INDESIT company

TAAN2X

F034630

Technical Documentation guidelines

51420c0 Exploded views

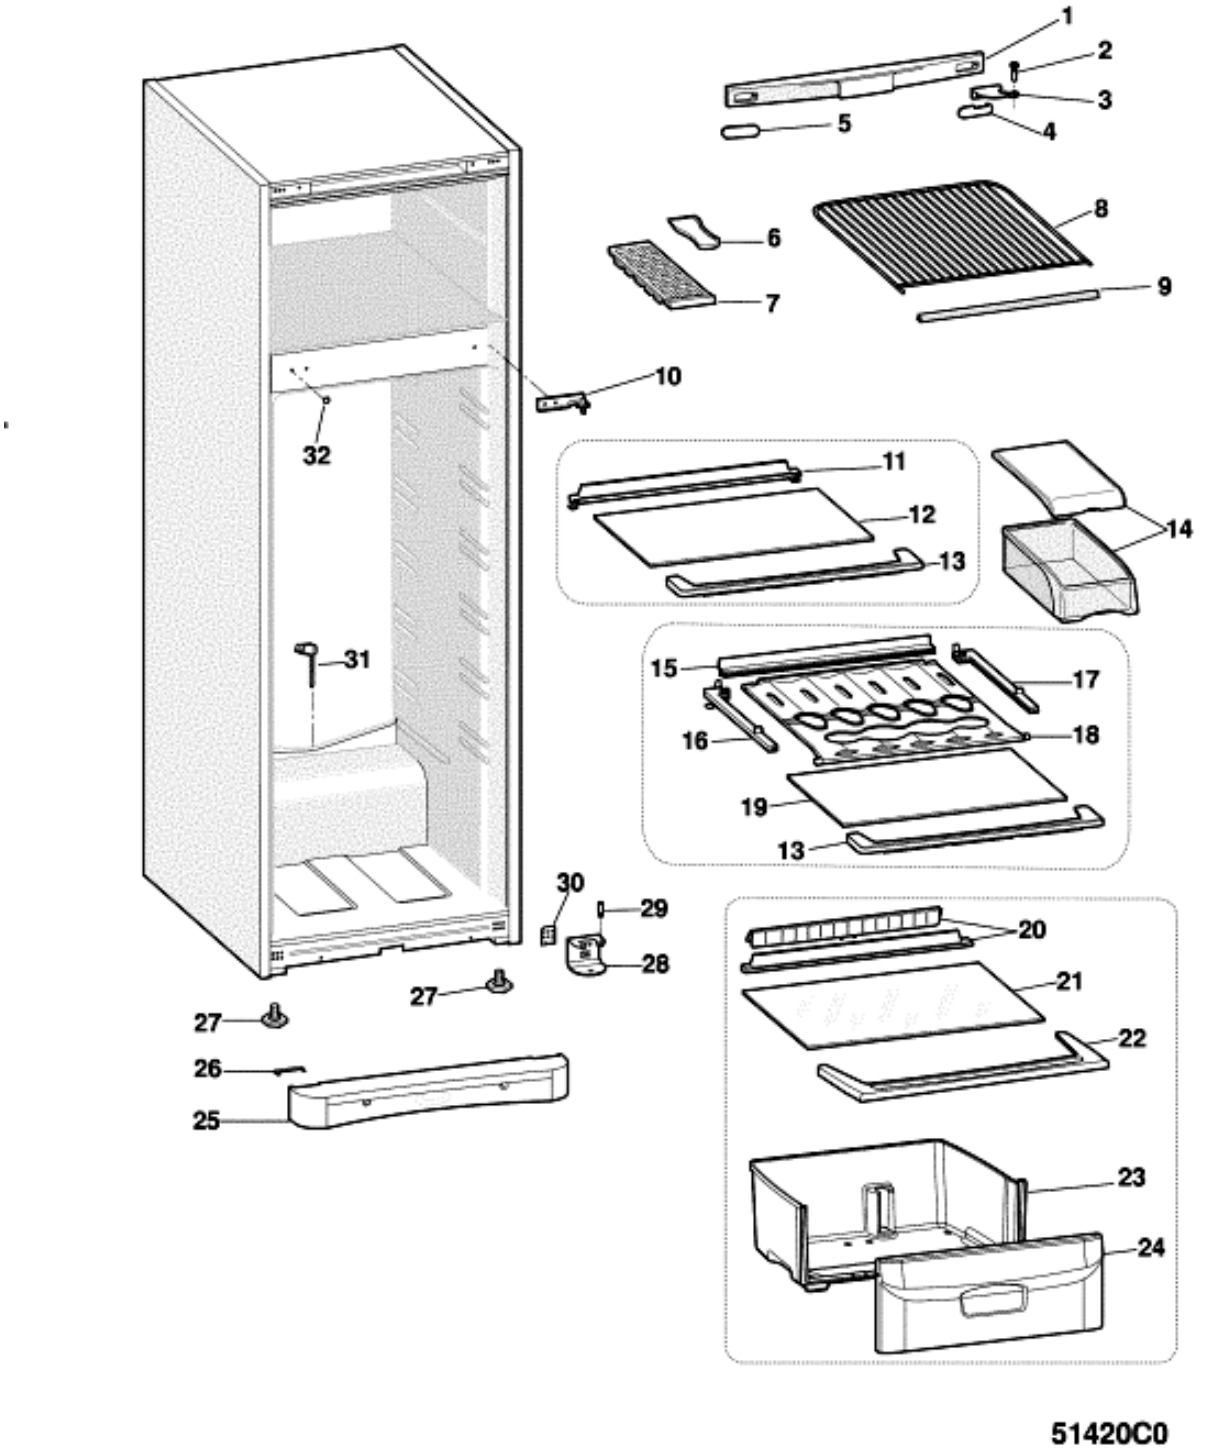
n2510j00: SUBSTITUTION LOWER HINGE PIN

In order to make better the assembly and to prevent an accidental unscrewing of lower hinge pin with consequent falling down of the door, original pin has been substituted by another one longer.

C00017658 (13.5mm) --> C00259768 (21mm) --> C00281425 (23mm)

For quality issues on interested models is managed only the last one C00281425 (23mm).

51421m0 Exploded views

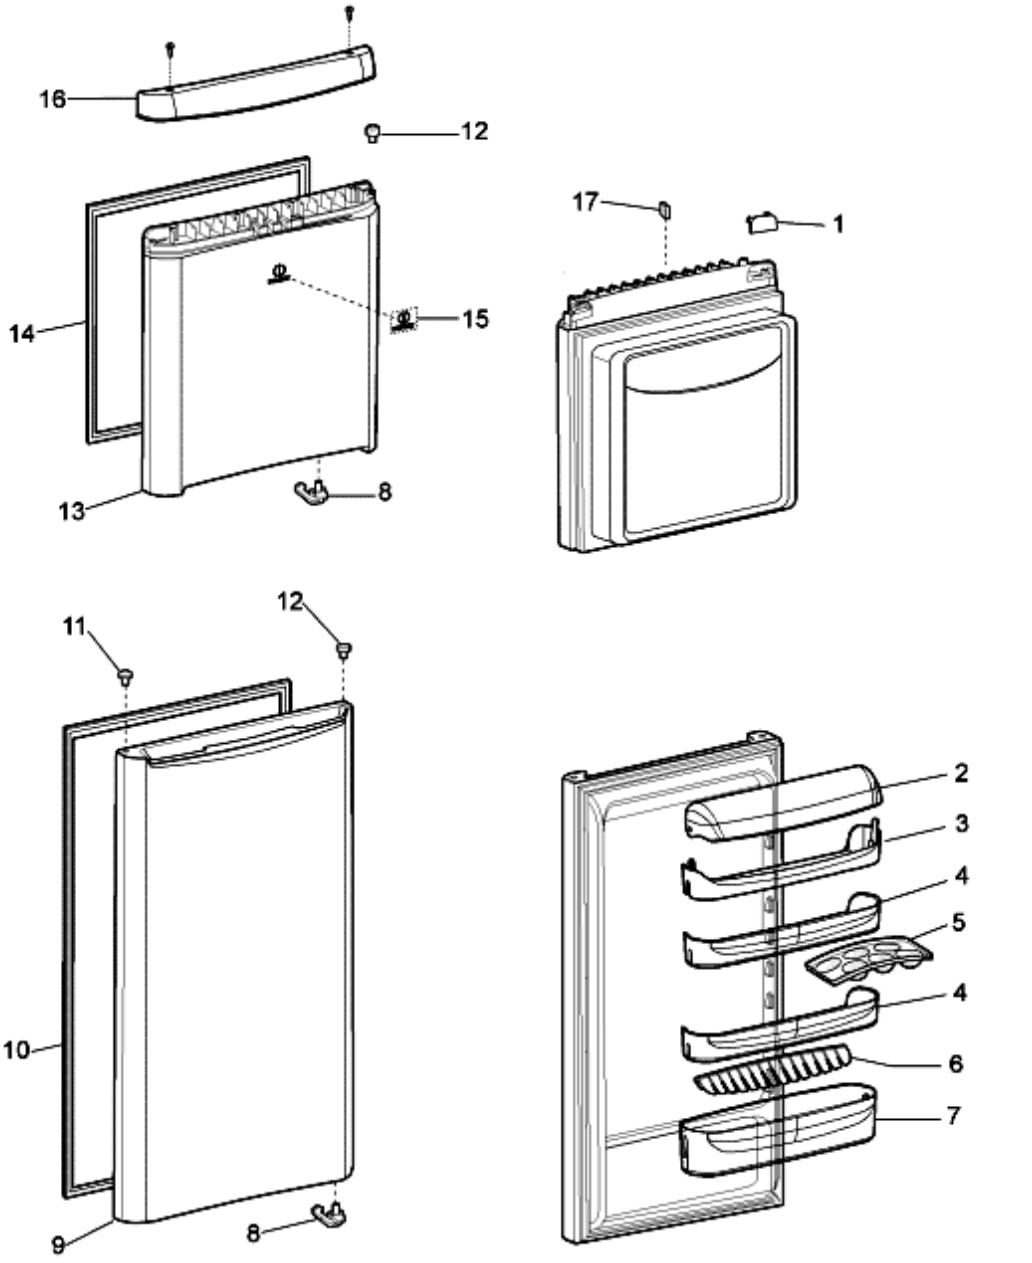
n2507b01: Color change on inner door upper heading

From s/n 70129.0001 (January 2007) on teak – inox – silver Indesit models has been introduction in production a new white inner door upper heading / white hinge blanking plate.

When replacing the door in the products produced before the modification replacing also the brown hinge blanking plate (for teak versions), grey (for silver version), aluminium (for inox versions) with the white.

n2511b02: ELIMINATION COVER FOR UPPER DOOR SHELF-INTERNAL ACCESSORIES RESTYLING

Cover for upper door shelf has been eliminated. The upper door shelf has been standardized with the middle one. Subsequently has been standardized with transparent internal accessories instead of those in light blue colour once stock has depleted.

n3010e00: SUBSTITUTION IRIDIUM AND INOX DOORS WITH DOORS IN MOTIVA N2 VERSION

From S/N 00215… in Lodz production IRIDIUM doors has been replaced with INOX version. Then INOX doors has been replaced with MOTIVA N2 version.

At the end of stock of old INOX doors, in assistance will be available ONLY spare parts of MOTIVA N2 doors so it will be necessary to replace (for models with S/N previous than MOTIVA N2 intro) both doors.

The spare part code of the door remain the same.

5142260 Exploded views

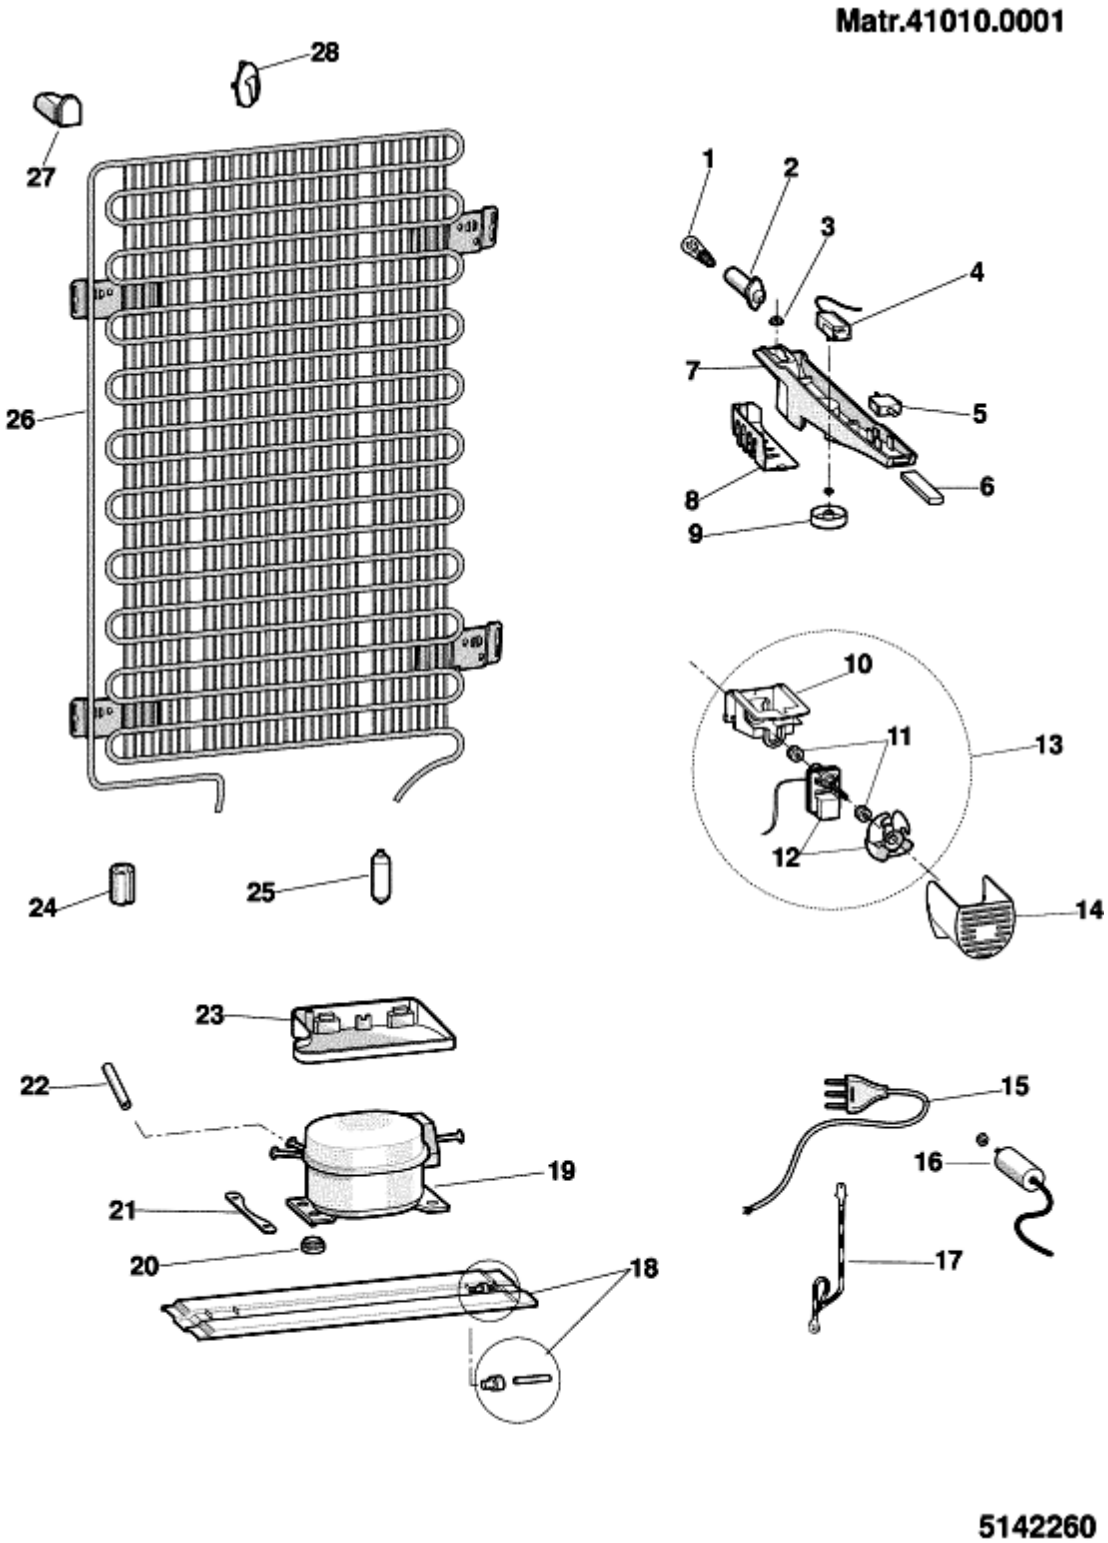
n1025135: Thermostat box on Indesit/Ariston Opera-60 refrigerators (low A.T. +16°C)

As of July 2003, two new "Low ambient temperature thermostat box kits" have been introduced as spare parts for Ariston Opera-60 and Indesit 2000 - 2002 - 2003 range refrigerators with Giugiaro thermostat box (075646).

The kit must only be used to solve freezer performance problems caused by an ambient temperature below +16° C.
This innovative kit features a DIODE, activated by means of the luminous switch, which makes the thermostat box lamp turn on.
It must be activated when the ambient temperature falls below +13°C (closed contacts: see the wiring diagram that comes with the kit).
The heat produced by the lamp activates the thermostat, thus ensuring regular operation of the appliance.
When replacing the thermostat box, no component can be reused (including the wiring).
The kit wiring has pin terminals for connection to the terminal block on the compressor; some modifications may be required for other solutions.
Given below is the list of kit items available as spare parts:
